Brewer Arena Improvements

Parks and Recreation Board
December 11, 2025

Objective

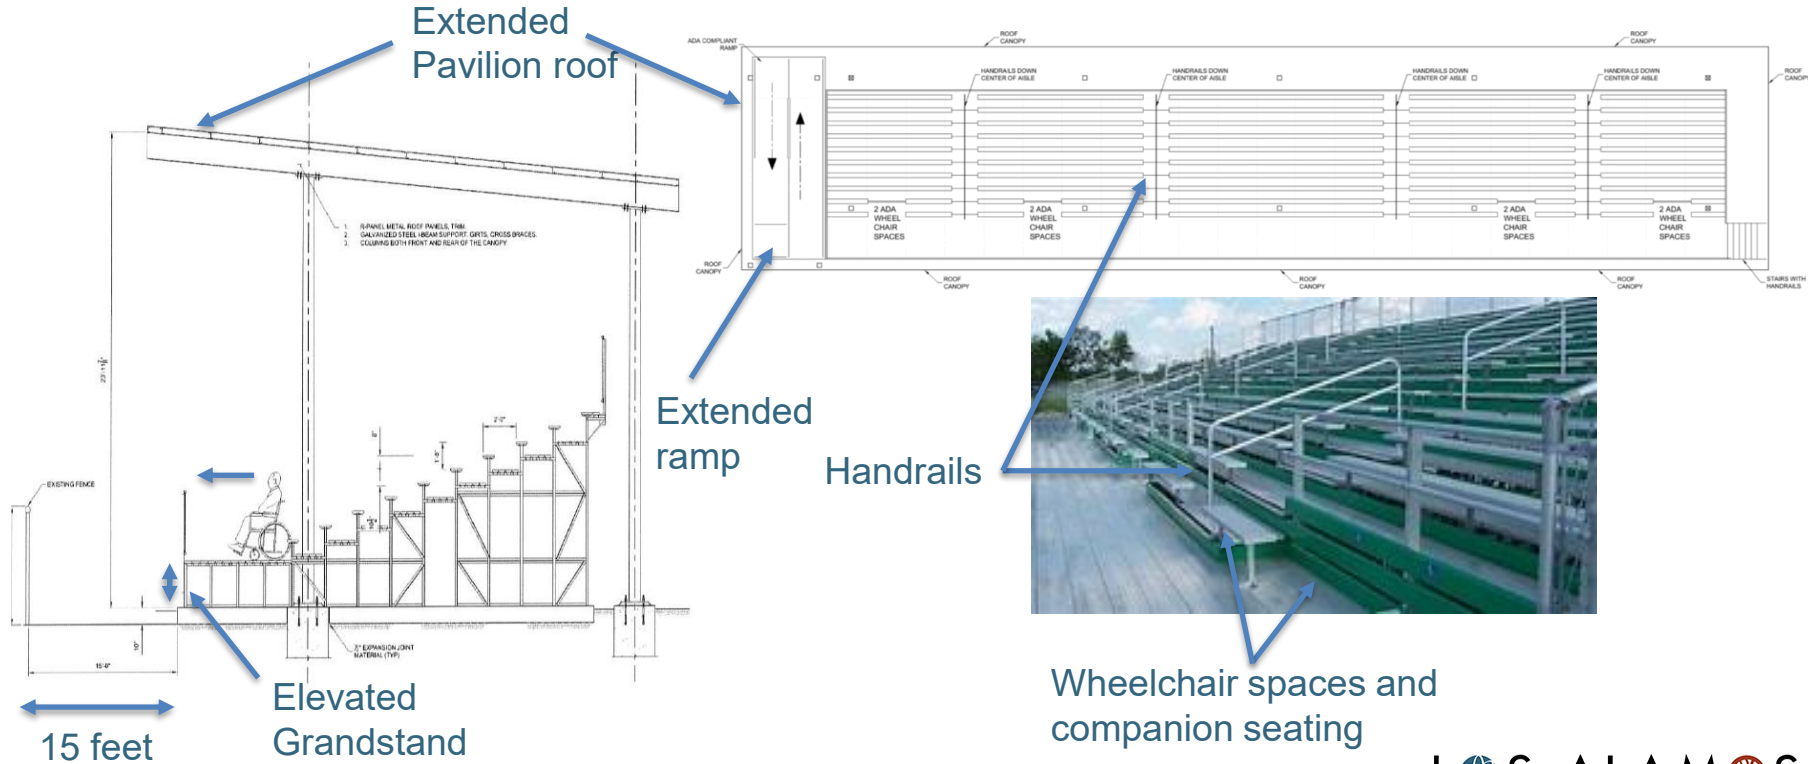
- Adjust elevation so that first row has unobstructed view over arena fence
- Center the seating on the “50 Yard Line”
- Grandstand to be 15’ away from arena fencing
 - West side arena access gates need to be unobstructed
- Make seating steps shallower/less steep and with handrails
- Extend the pavilion to provide cover for the entire seating, access ramp, and walkway

Additional Feedback from Equestrian Working Group

- Provide a breakdown of the cost increase

- Raise Grandstand elevation (requires extension of ADA ramp)
- Center Grandstand on “50 Yard Line”
- Place Grandstand 15’ from the arena fencing
 - Ensure access gates are unobstructed
- Seating incline and handrails meets standards
- Correct obstruction of arena access gates if needed
- Enlarge Pavilion
- Estimated Budget Impact: \$320,000

Grandstand elevation increase	\$ 90,000
Pavilion extension	\$192,000
ADA Ramp extension	<u>\$ 38,000</u>
TOTAL:	\$320,000
- Support raising the grandstand and adjusting the ADA ramp
- Support not extending the pavilion roof to reduce impact on project budget
- No consensus regarding appropriate grandstand capacity (next two slides)

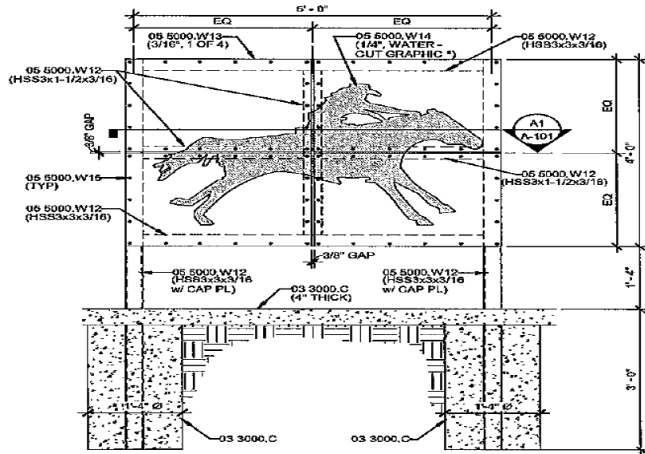
- Sink placement does not allow turnaround wheelchair access
- Restroom capacity will not satisfy the full demand

- Requested code analysis
- Architect of record states that the restroom design is conducted in accordance with ADA standards *ANSI A117.1* as adopted by the State of New Mexico and as listed in the *2021 International Building Code*. Specific ADA of A117.1.

- Restroom upgrades meet ADA requirements
- Restroom capacity can be increased through the placement of temporary facilities when needed
